**IN THE DRAWINGS**

REMARKS

FIG. 7

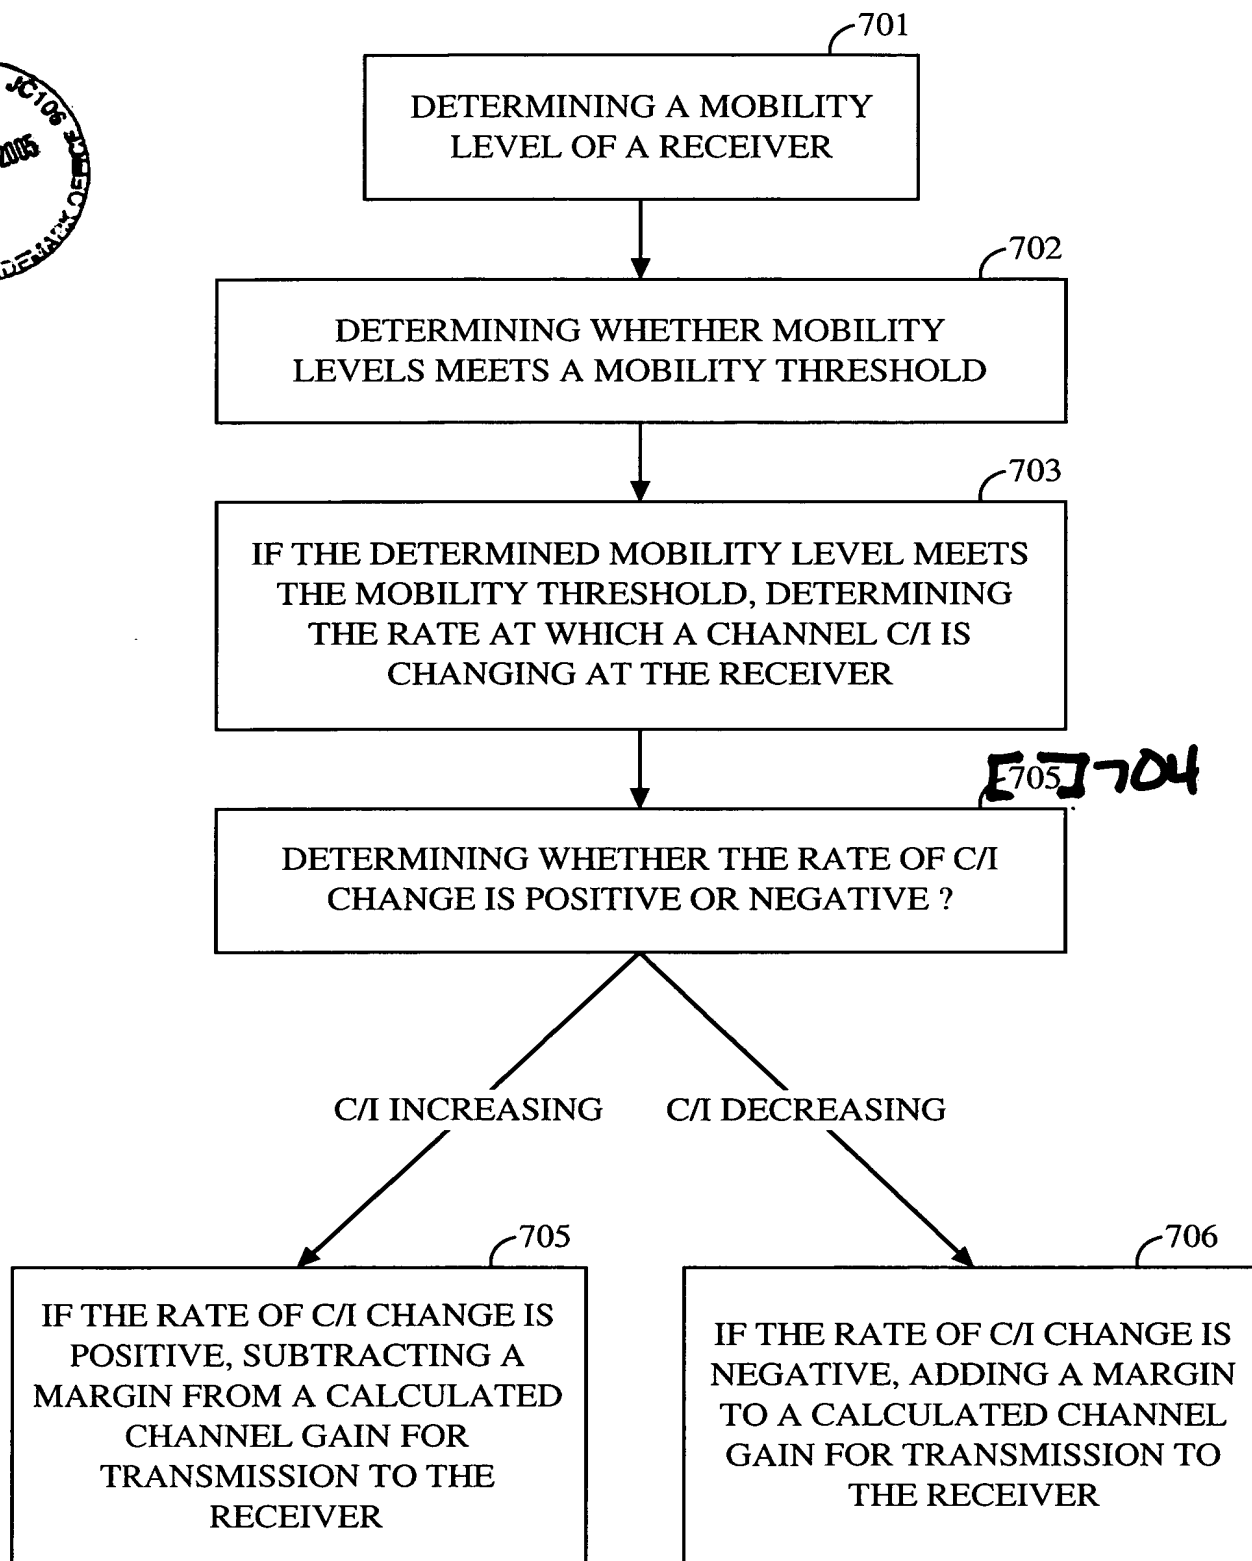
Specifically, in Figure 7, please change the reference character 705 used to designate the block with the wording “determining whether the rate of C/I change is positive or negative” to the reference character 704, corresponding to the specification, paragraph 00037.
